Product Change Notice (PCN)

PCN Number: PCN-0456242R-02

Product(s) Affected: *SJ1-353XNS Series (SJ1-3533NS, SJ1-3534NS, SJ1-3535NS)*

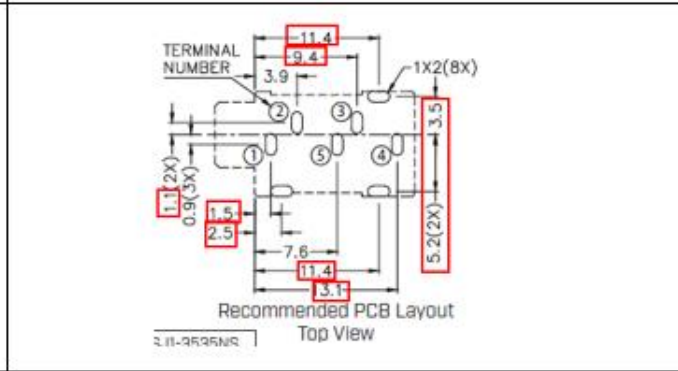
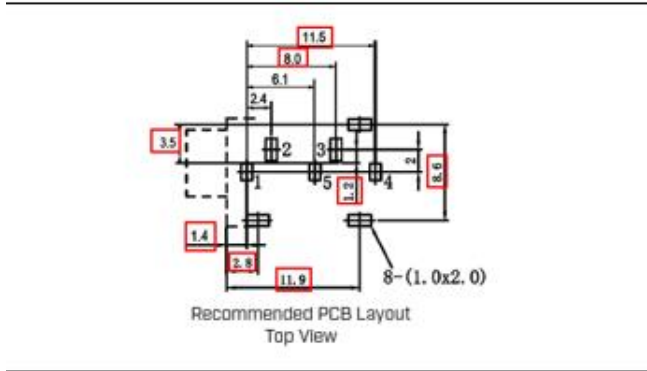
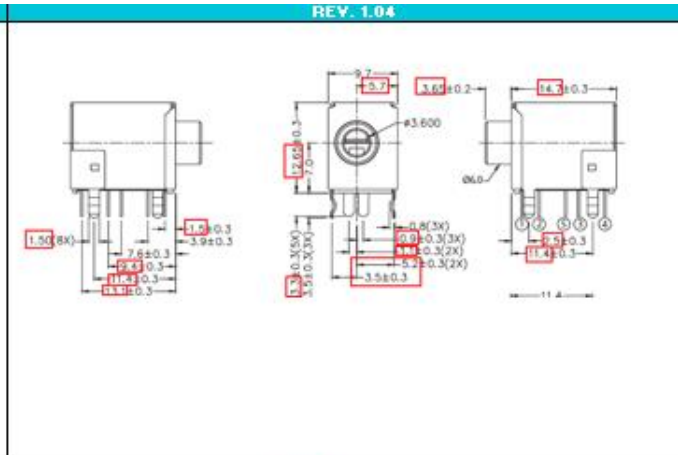
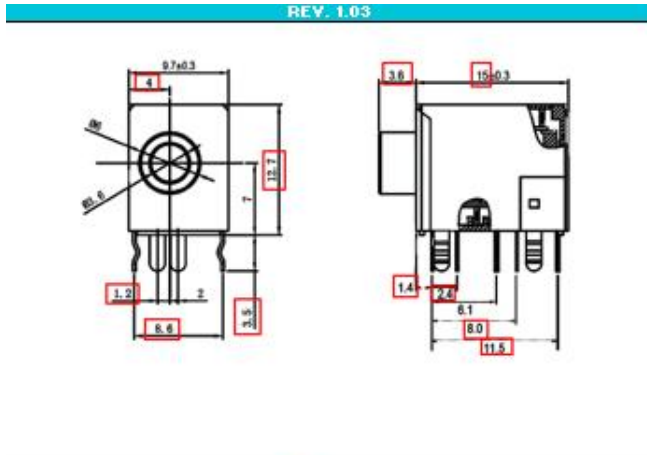
Description of Change: *Minor Layout and Material Difference. See image Below*

DESCRIPTION	MATERIAL	PLATING/COLOR
terminal 1	brass	silver
terminal 2	phosphor bronze	silver
terminal 3	phosphor bronze	silver
terminal 4	brass	silver
terminal 5	brass	silver
spring	stainless steel	nickel
bushing	brass H58	nickel
shield	SPCC t=0.30	nickel
housing	PBT (UL94V-0)	black

DESCRIPTION	MATERIAL	PLATING/COLOR
terminal 1	brass	tin
terminal 2	brass	tin
terminal 3	brass	tin
terminal 4	brass	tin
terminal 5	brass	tin
spring	stainless steel	nickel
bushing	brass	nickel
shield	cold rolled steel	nickel
housing	PBT (UL94V-0)	black
